# Planning Commission Staff Report

## 1722 West 2700 North

Site Plan for Fast-Food Restaurant

October 3, 2024

ATTACHMENT 3) Building Elevations | Proposed

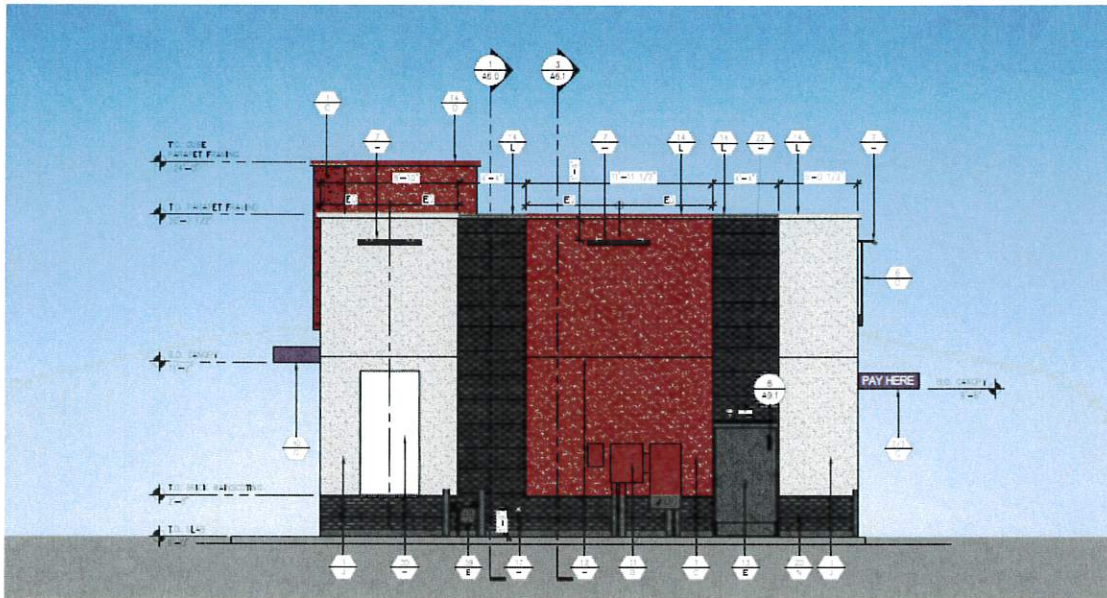
The proposal appears consistent these standards, but the information reviewed in plans does not provide a clear indication of the breakdown of percentages for building materials. Awnings included in the submitted plans are metal, which is consistent with the requirements in City Code.

1. Confirming that building exteriors materials in the Gateway West Area are consistent with meeting requirements of brick, stucco, and/or stone, which include no more than 30% of the building exterior comprising of stucco and no more than 60% comprising of glass. If inconsistent, working with the Development Review Committee (DRC) to make appropriate adjustments to building materials prior to issuance of a building permit.
2. Confirming materials for pedestrian crossings meet standards in Code.
3. Providing detailed lighting plans and components meeting DRC approval through ensuring that all lighting standards are being met.
4. UDOT Final Approval of Site Plan traffic patterns.
